Title - Sujet Revitalisation du havre Grosse-Île		
Solicitation No. - N° de l'invitation F3731-190013/A		Amendment No. - N° modif. 003
Client Reference No. - N° de référence du client F3731-190013		Date 2020-09-04
GETS Reference No. - N° de référence de SEAG PW-\$QCM-041-17972		
File No. - N° de dossier QCM-0-43076 (041)	CCC No./N° CCC - FMS No./N° VME	
Solicitation Closes - L'invitation prend fin at - à 02:00 PM on - le 2020-09-24		Time Zone Fuseau horaire Heure Avancée de l'Est HAE
F.O.B. - F.A.B.		
Plant-Usine: <input type="checkbox"/> Destination: <input checked="" type="checkbox"/> Other-Autre: <input type="checkbox"/>		
Address Enquiries to: - Adresser toutes questions à: Beauchesne, Sonia		Buyer Id - Id de l'acheteur qcm041
Telephone No. - N° de téléphone (418) 576-9803 ()		FAX No. - N° de FAX (418) 648-2209
Destination - of Goods, Services, and Construction: Destination - des biens, services et construction:

Amendment 003

The closing date for solicitation F3731-190013/A, titled “Harbour revitalization Grosse-Île (Magdalen Islands)”, is extended from September 17, 2020 until **September 24, 2020 at 2:00 PM.**

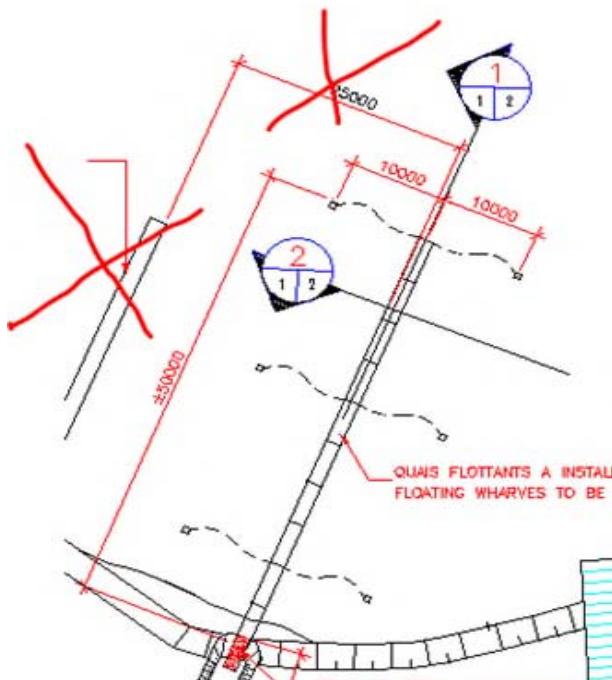
Q16. Is it possible to have more details on the existing floating docks system that is to be removed? (anchor blocks on the sea bottom and the number / cables / etc ...)

A16. The floating docks with blocks and chains to be handed over to Departmental Representative is made up of 3 series of 2 anchor blocks spaced about 10 m from the floating dock line (see sketch on next page)
